AGENDA
PLANNING COMMISSION REGULAR MEETING
Wednesday, April 19, 2023, at 6:00 PM

Date: 9.12.22 Resubmitted: 12.16.22, 2.7.23
 Project Name/Contact: Ziggi's Severance/Paul Bass (TST)
 Project Address: 9843 E. Harmony Road
 Customer/Project Number: 284 - American Eagle Properties attn. Jerry Helgeson
 Review Number: 3rd Submittal
 Project Coordinator: Abdul Barzak, Town Planner
 Recipients:

SUBJECT: Ziggi's Coffee – Site Plan

ZIGGI'S SEVERANCE SITE PLAN

GRADING & EROSION PLAN

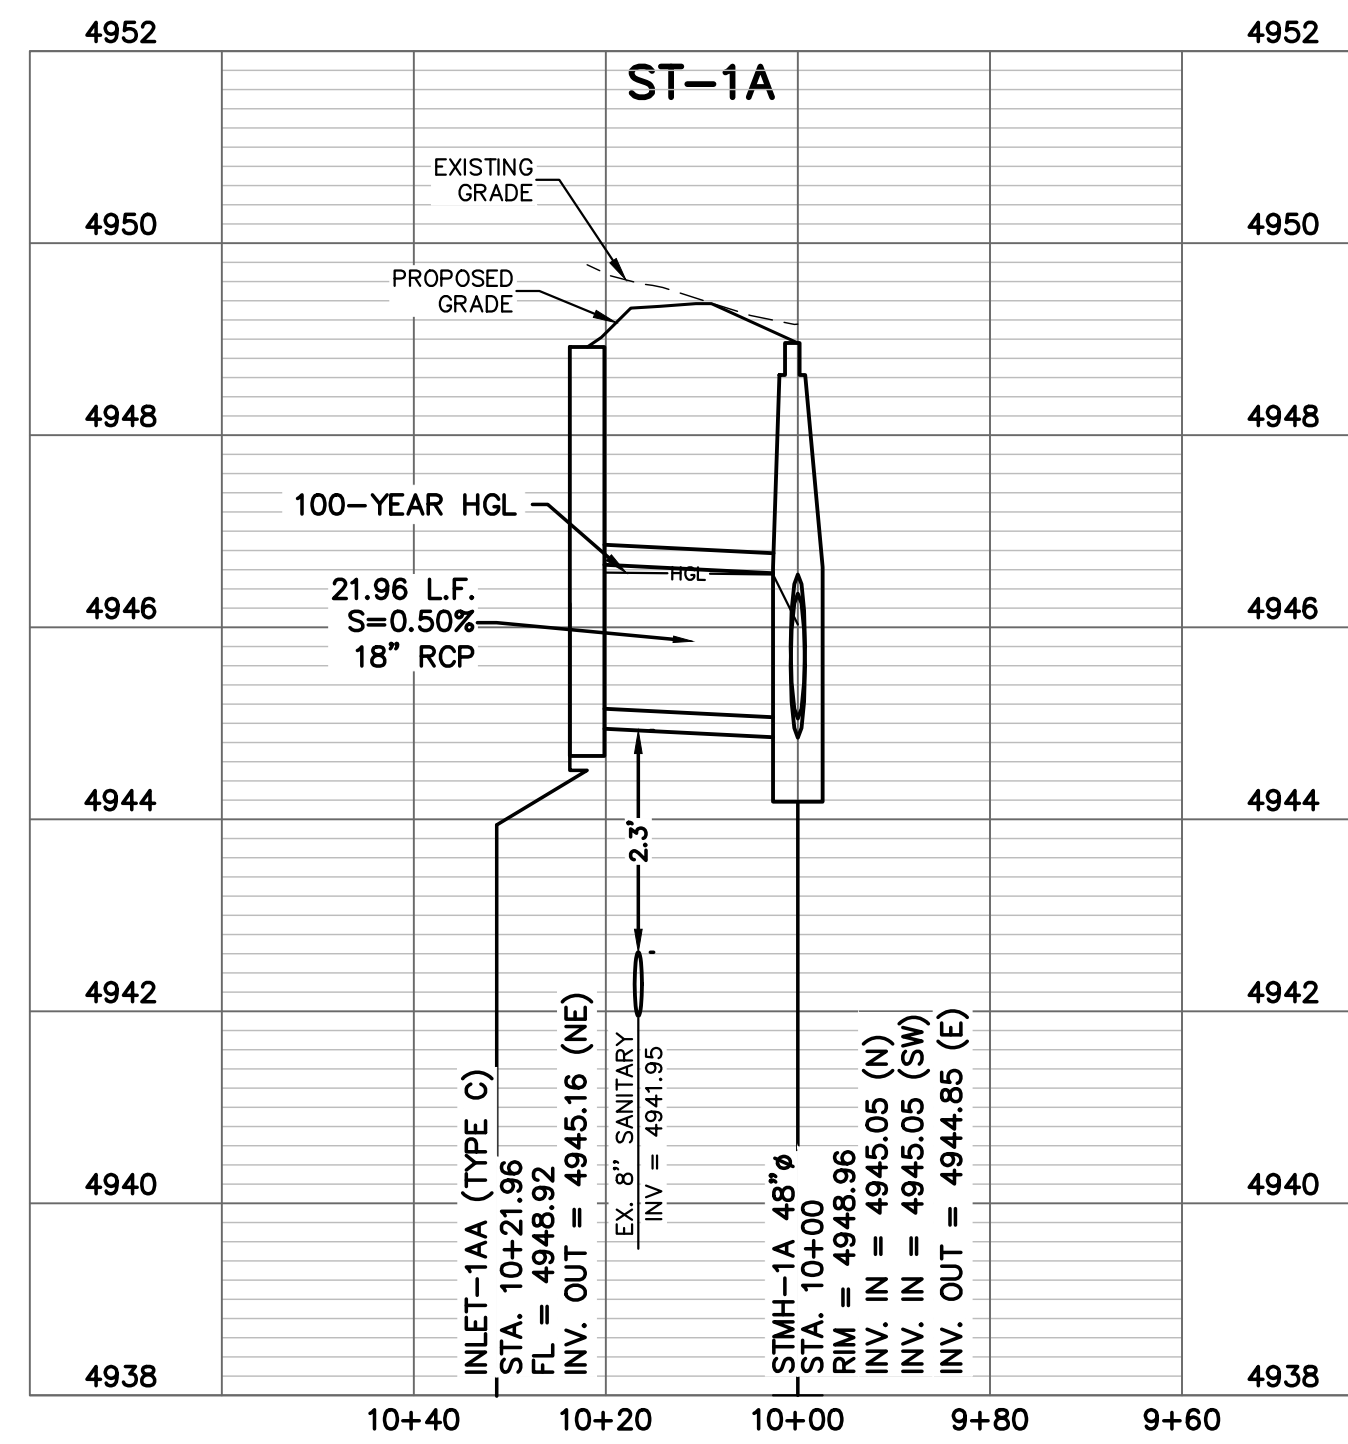
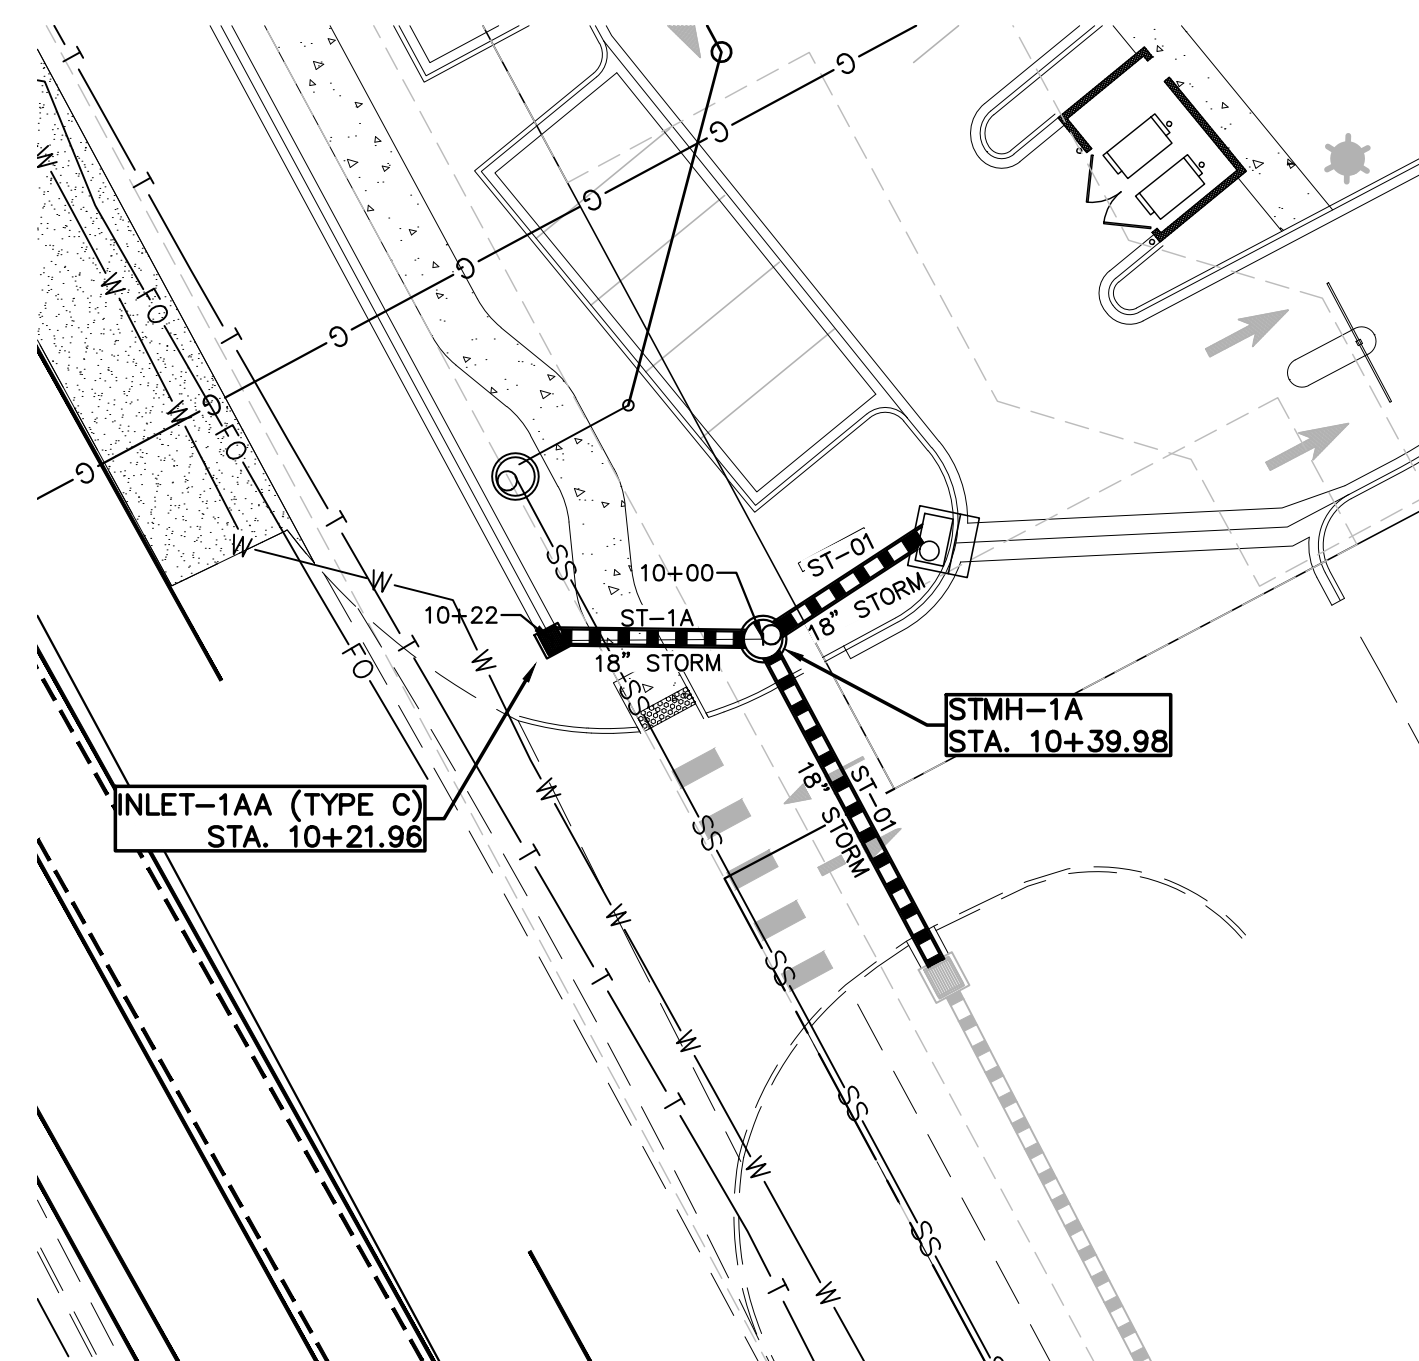
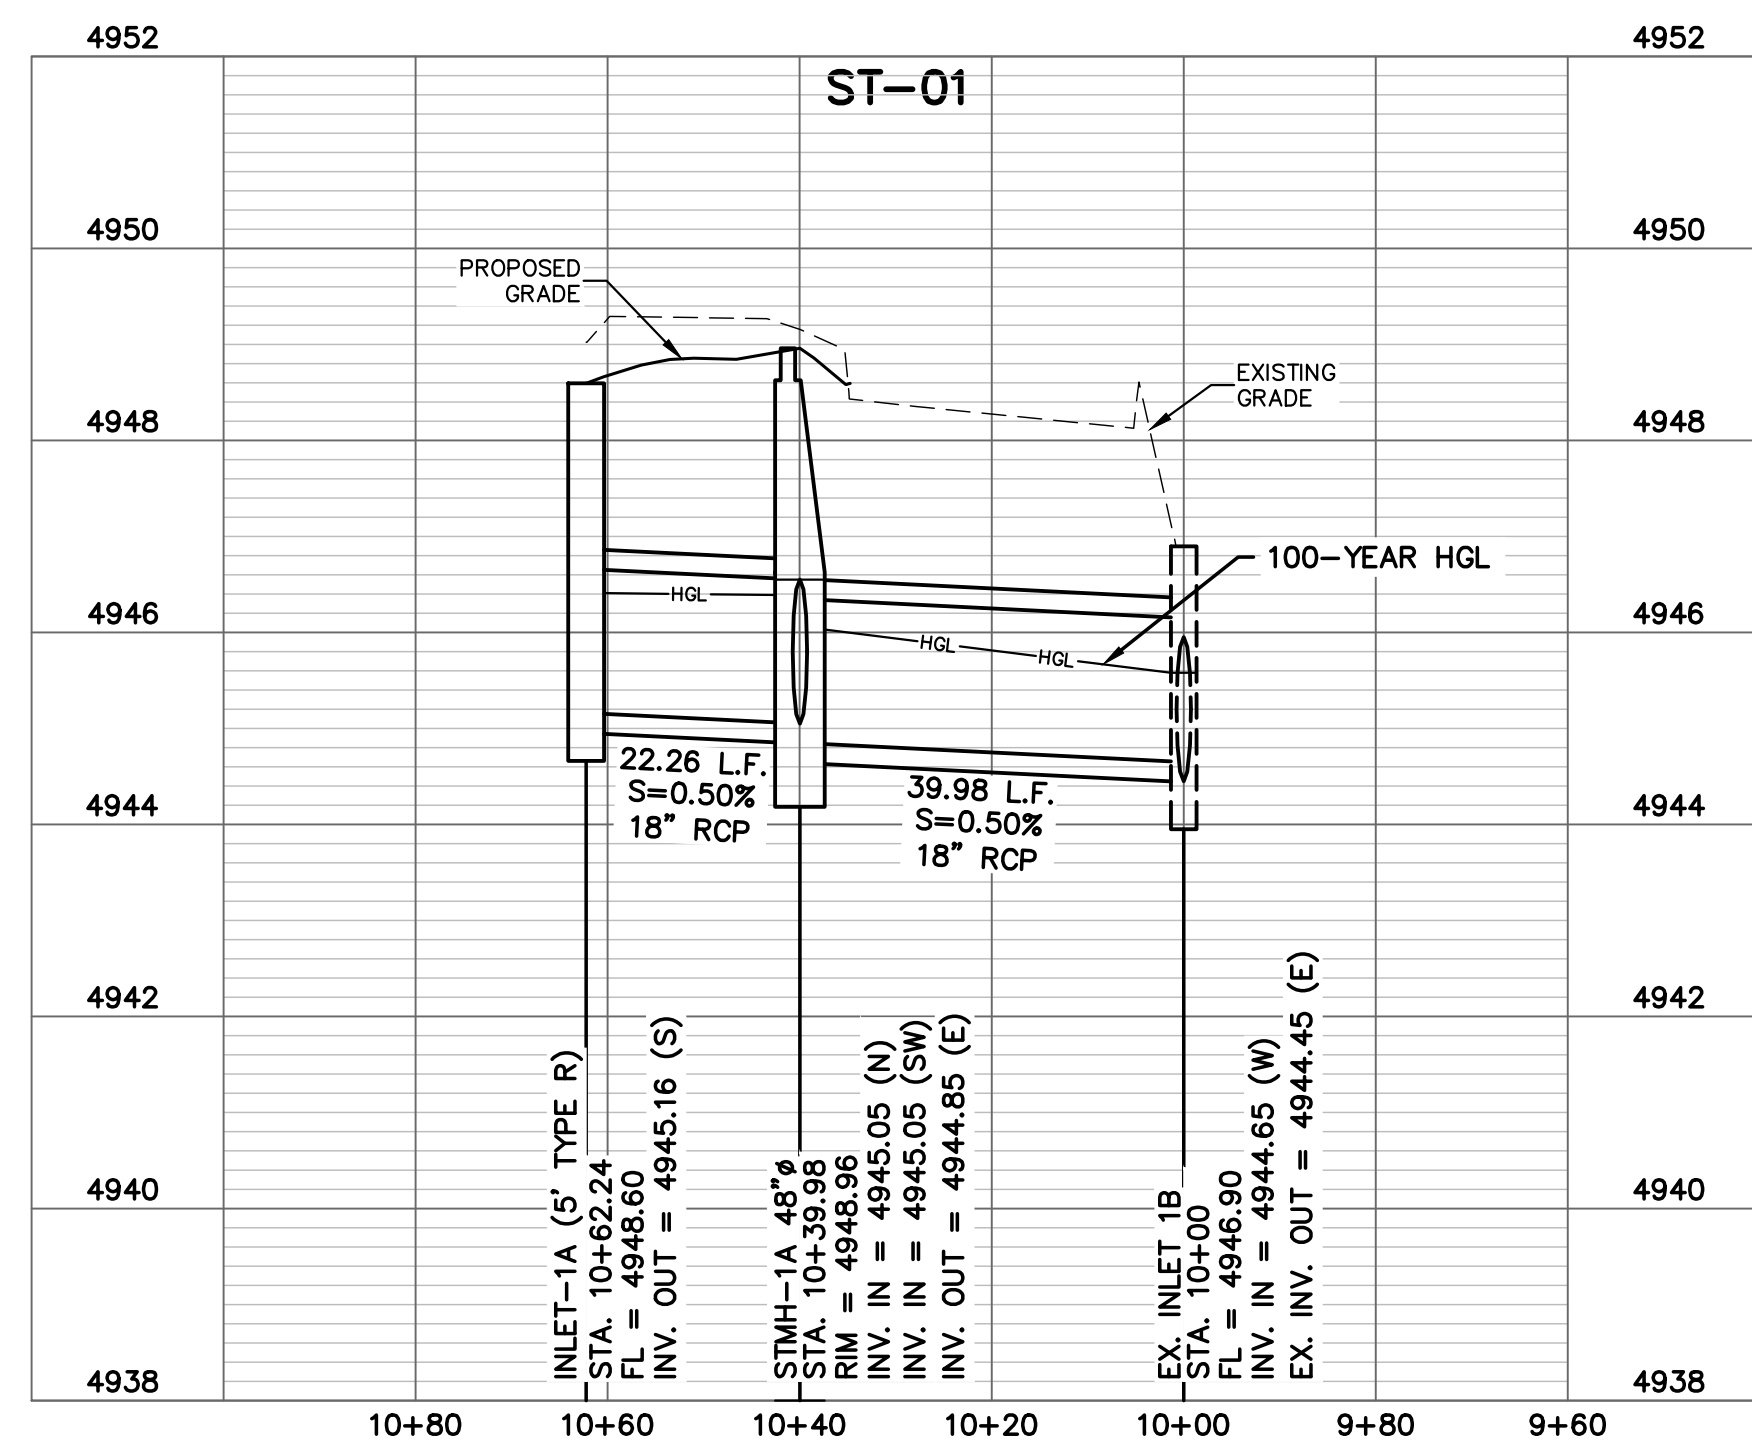
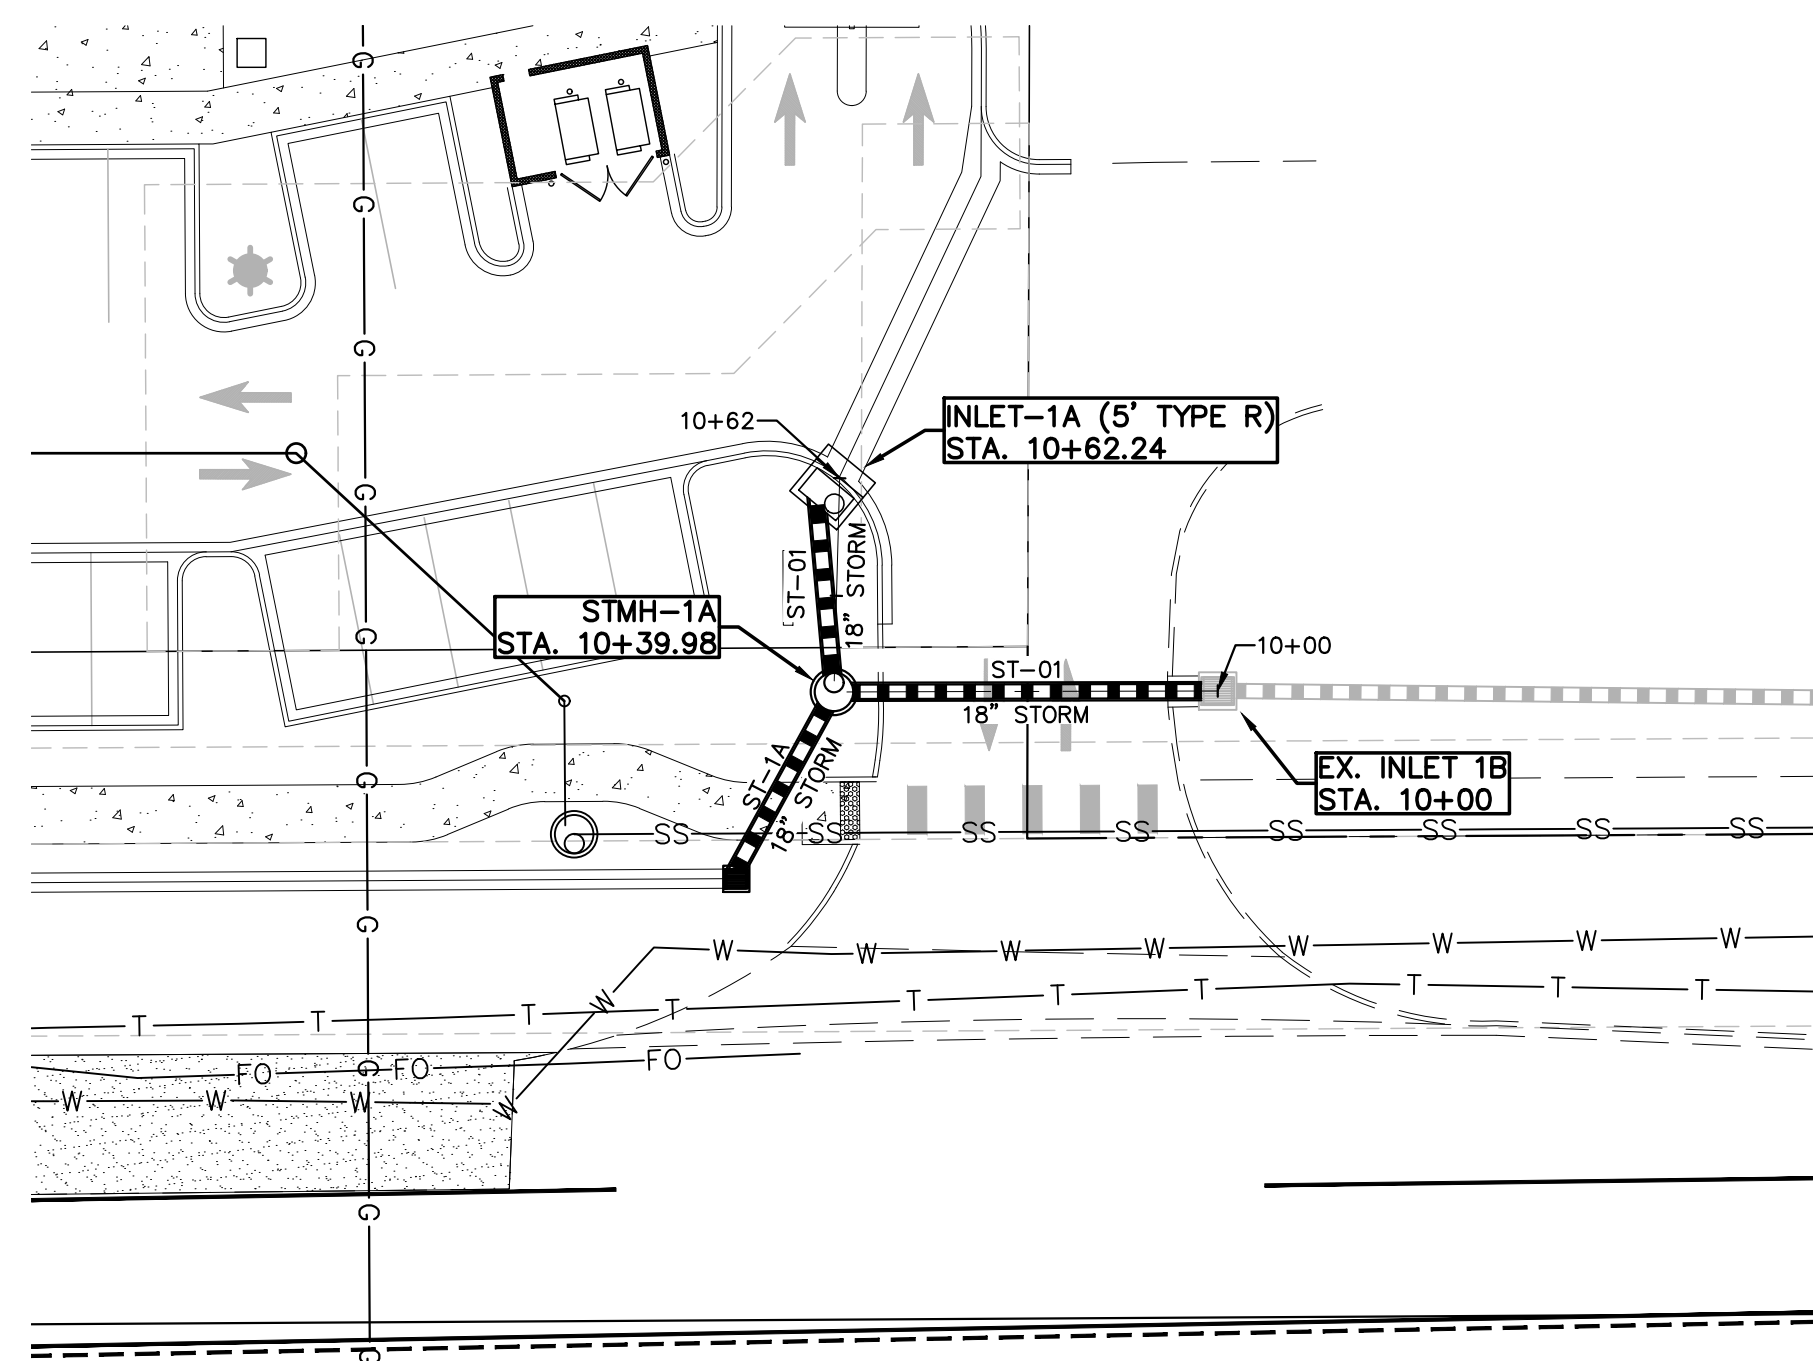
16. Sheet 4 (Site Plan, Encroachment) – A portion of the private improvements (parking lot) encroaches in the public road ROW of E Harmony Rd (WCR 74). The encroachment does not impede the widening of E Harmony Rd (WCR 74) to the ultimate section of 4 lanes of through traffic. As shown, when E Harmony Rd (WCR 74) is widened to the ultimate section the standard 24’ landscape strip would be reduced to 10’ along this property and the 6’ sidewalk would be located approximately 14’ inside the ultimate ROW instead of along the ROW. Engineering does not have an issue with the encroachment.

17. Sheet 4 (Site Plan, Site Access) – The site access is an existing private access created for the adjacent lot which contains the Dollar General Store. Refer to Town Attorney Comments. Site access modifications and construction need to be coordinated with Dollar General.
